STAFF RECOMMENDATION 933 Fatherland Street June 21, 2017

Application: Demolition—outbuilding; New construction—detached accessory dwelling unit; Setback determination

Description of Project: Application is to demolish existing outbuildings and to construct a detached accessory dwelling unit (DADU) at the rear of the lot. The structure requires a rear setback determination from twenty feet (20') to thirteen feet (13'). The structure contains an uncovered balcony, supported by brackets, that is twenty-eight square feet (28 sq. ft.).

site plan

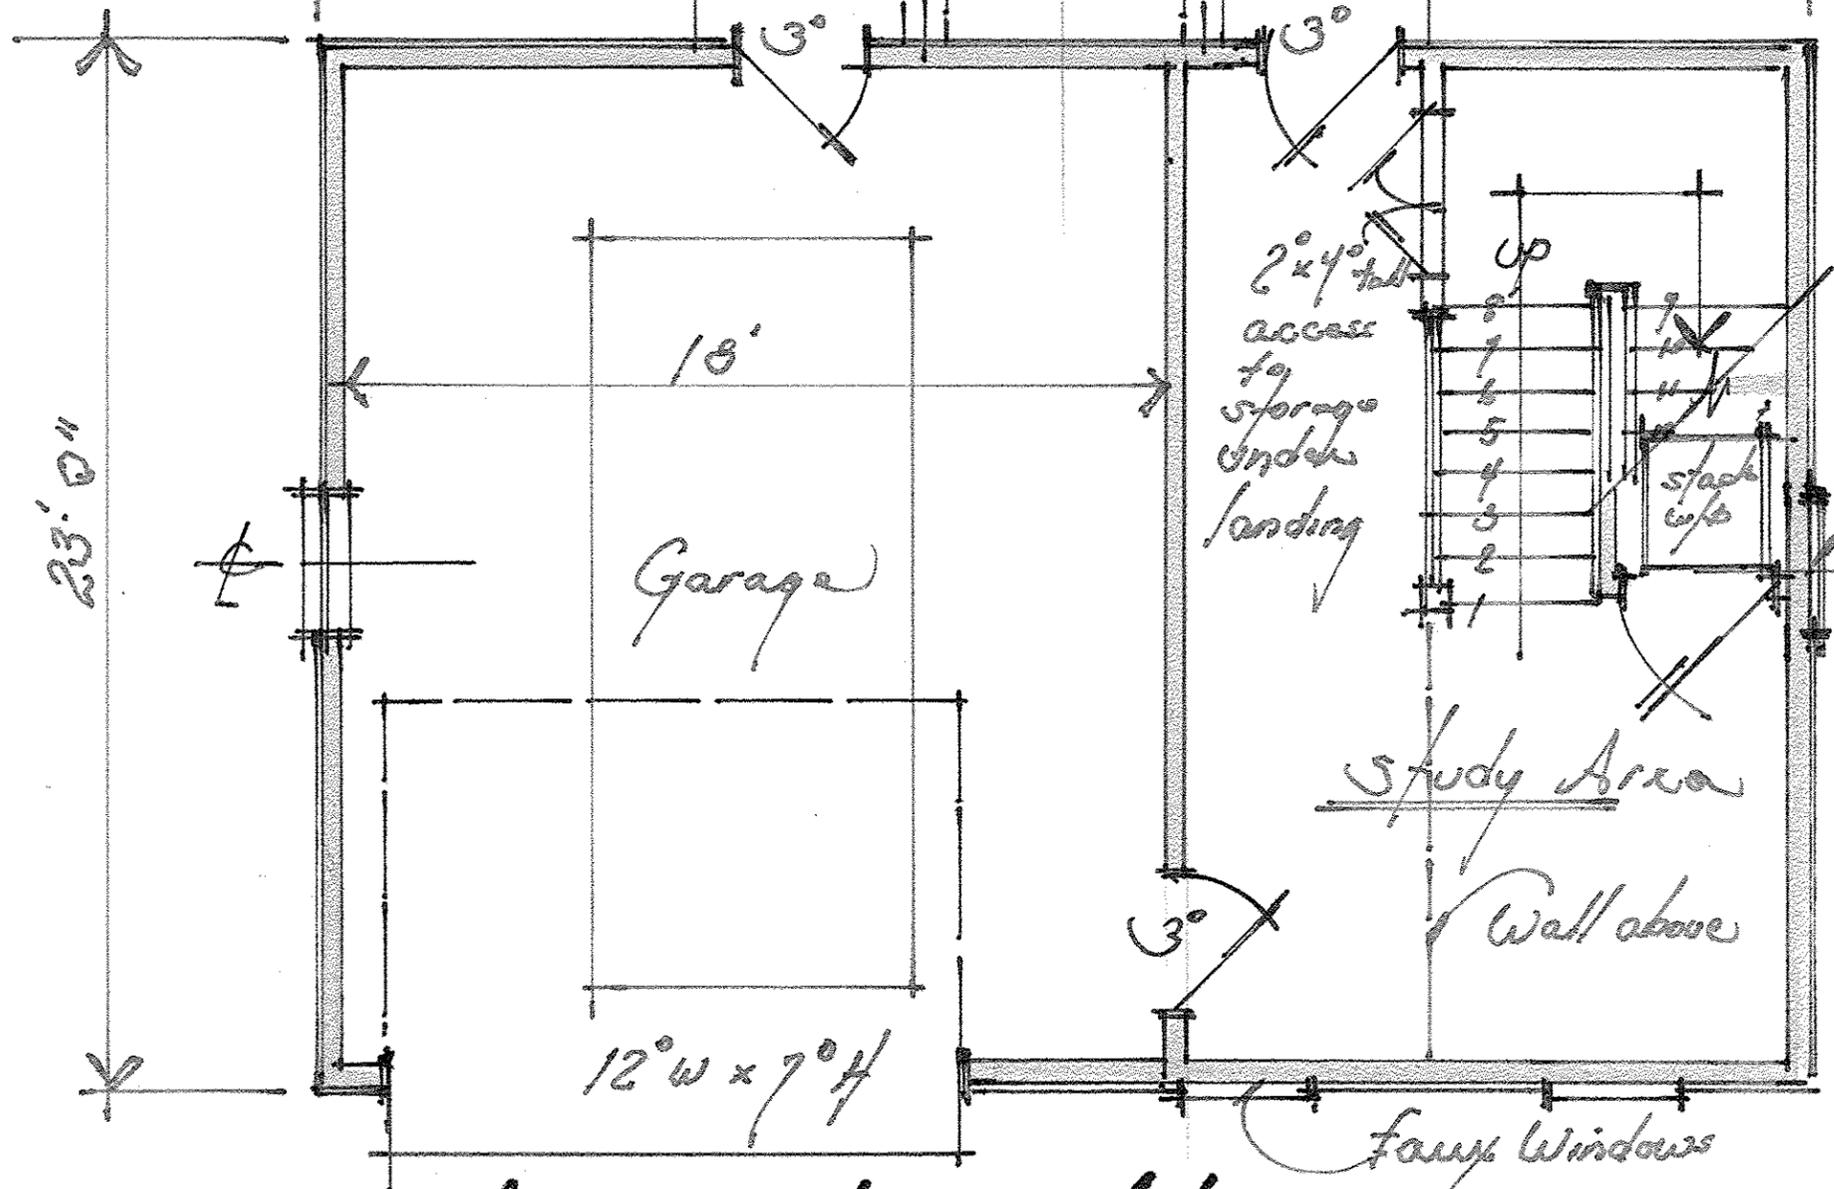
MINIMUM	PROPOSED
Space between principal building and DADU/Garage	20'	65'
Rear setback	20'	10' *
L side setback**	5'	5'
R side setback**	5'	12'
How is the building accessed?	From the alley or existing curb cut	From alley

*For outbuildings that have footprints that are larger than seven hundred square feet (700 sq. ft.) like this one, the base zoning setbacks are five feet (5') from the side property lines and twenty feet (20') from the rear property line. In this case, the proposed DADU will meet the base zoning side setbacks, but will need a setback determination for the rear setback.

Staff finds that the proposed ten foot (10') rear setback to be appropriate because historically, outbuildings were situated close to the rear and side property lines. A ten foot (10') rear setback is more historically appropriate than a twenty foot (20') rear setback. In addition, if the DADU were less than seven hundred square feet (700 sq. ft.), the base zoning rear setback would be ten feet (10'). The reduced rear setback also allows for more space in between the house and the outbuilding, which is appropriate. Staff therefore recommends approval of the setback determination, finding that the proposed setbacks meet Section III.B.2.h.2. of the design guidelines and 17.16.030.G. 4 of the ordinance.

First Floor Plan

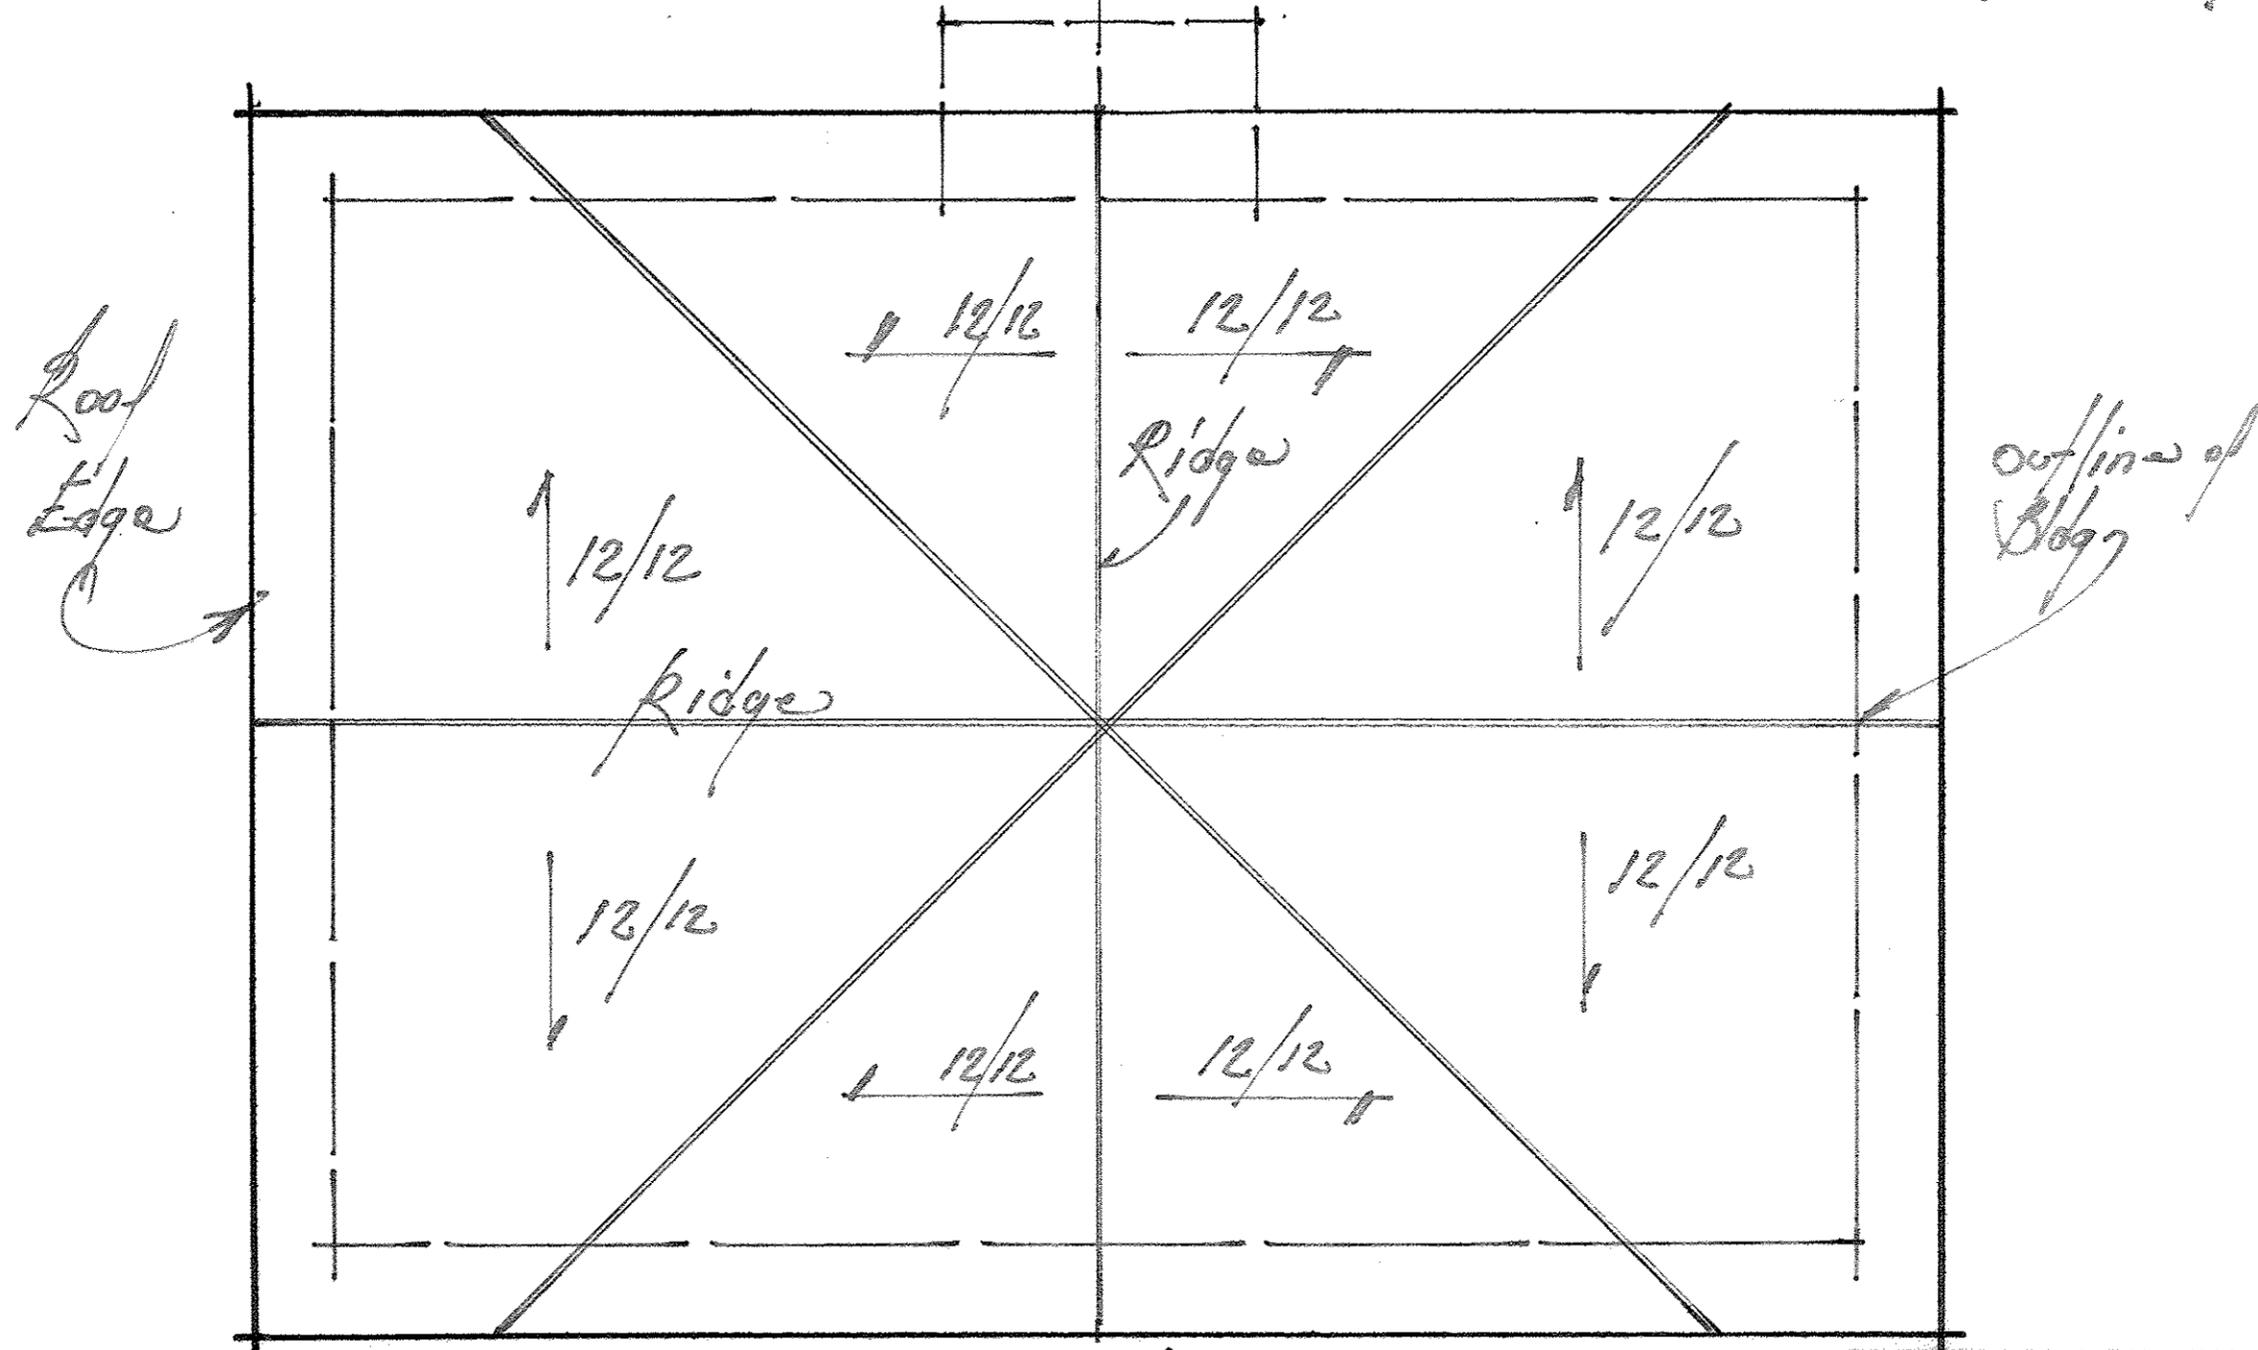
*The applicant is proposing an uncovered balcony that is seven feet (7') wide and four feet (4') deep, or twenty-eight square feet (28 sq. ft.). The balcony is supported by brackets. If this balcony is included in the calculation of the footprint, it would push the DADU's footprint over the allowed seven hundred and fifty square feet (750 sq. ft.). Staff recommends that the Commission consider creating a policy regarding balconies on outbuildings and DADU. Staff recommends that upper level balconies on outbuildings

- They are located either facing the principal house or the rear of the lot; they would not be permitted facing the side property lines;
- The outer facing railing meets the base zoning setbacks;
- The footprint is limited to thirty square feet (30 sq. ft.) or less;
- The balcony is uncovered; and
- The balcony does not have posts to the ground.

Staff finds that the proposed balcony meets these criteria, and staff recommends that the Commission approve the balcony as a test case and review it again once constructed. If the Commission finds the balcony to be appropriate, the above criteria could be added to the NCZO design guidelines as italicized information.
